## TECHNICAL MEMORANDUM

FROM: Glen Leverich  
Senior Geomorphologist/Geologist  
Stillwater Sciences

SUBJECT: Comments on the Surface Water Hydrology and Flood Control, and Geomorphology and Riparian Resources Sections of the Newhall Ranch RMDP-SCP Final EIS/EIR, June 2010

FIGURE 4.2-1

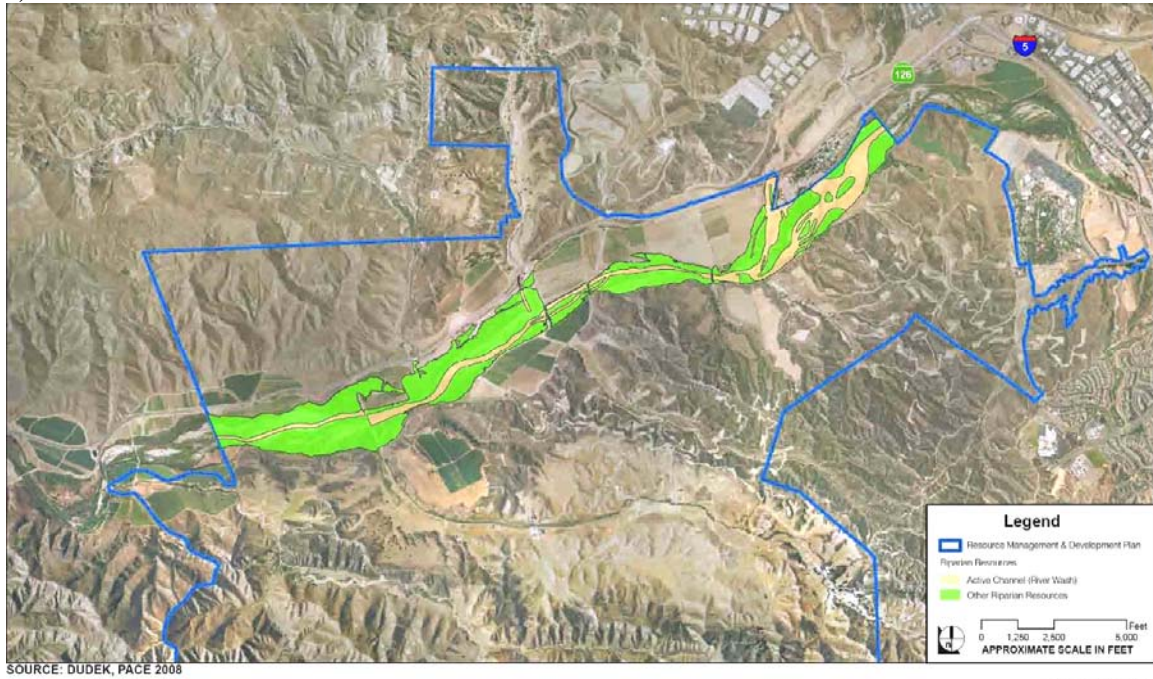
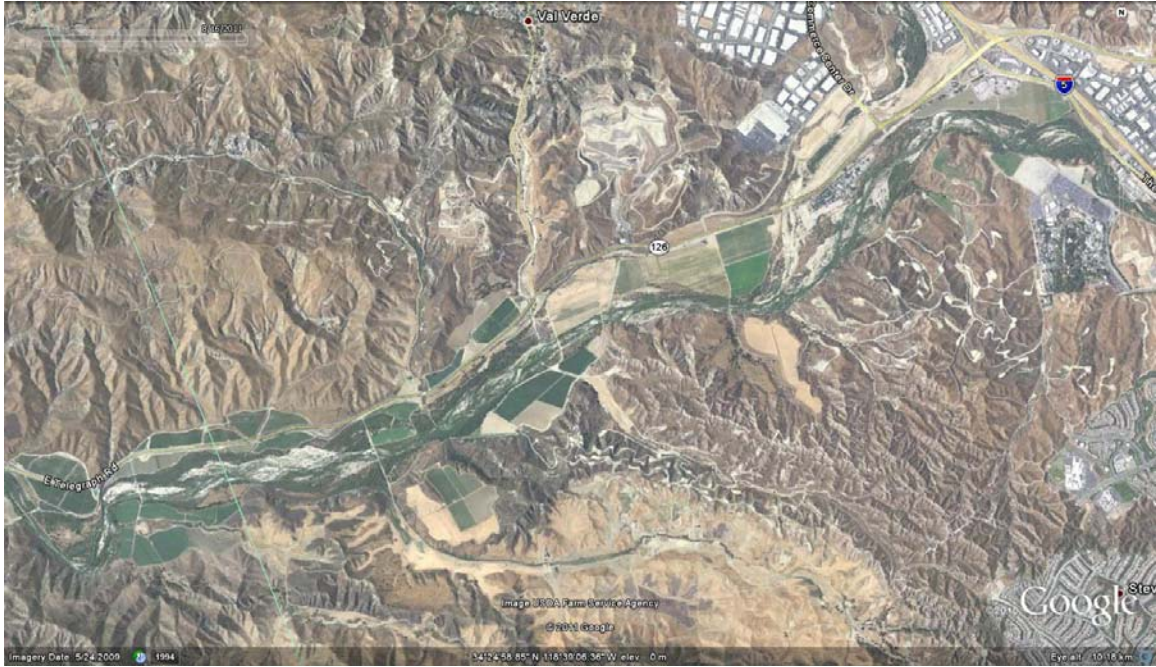
- Figure 4.2-1 (“Riparian Resources”) grossly underestimates the planform extent of the “active channel” path. It is unclear what methodology was employed to define this extent. We and others define the active channel area, or width, as part of the mainstem channel bed that has carried a significant part of the flood and sediment discharge during the recent flood events (see Simons, Li & Associates 1983, 1987, and Stillwater Sciences 2005, 2007, 2011a, b). We previously mapped active channel areas following the river’s largest floods in Ventura County, which could have been used as reference in this analysis (see Stillwater Sciences 2005 and 2007). We recently mapped active channel areas in the project area as part of the upper SCR study (see Stillwater Sciences 2011a, b). It can be clearly seen in our maps that the geomorphically active channel areas are considerably broader than those shown in Figure 4.2-1 of the FEIS/R (see also the comparison on the last page of this memo). Specifically within the project area boundaries, the floodplain area where the proposed “Landmark Village” development will be constructed (between the river’s right bank and Highway 126) was most recently flooded and scoured during the 1983 flood event, for which we determined the peak instantaneous flow to have a recurrence interval of 15 years (based on 57-year gauge record at the County line and new SCR NR Piru station: WY 1953–2009). This demonstrates just how active the entire channel width and floodplain can be during these episodic events.

Comparison of designated “active channel” zone from Section 4.2 of the FEIR/S (a) with scaled views of the river before in 2006 (b) and after in 2009 (c), showing significantly greater areas of fresh sediment-transport activity and flow than shown in the mapped “active channel” zone in the FEIR/S figure (a). Also shown is our “active channel” mapping (d) showing the geomorphically active channel areas following a series of historical flood events.
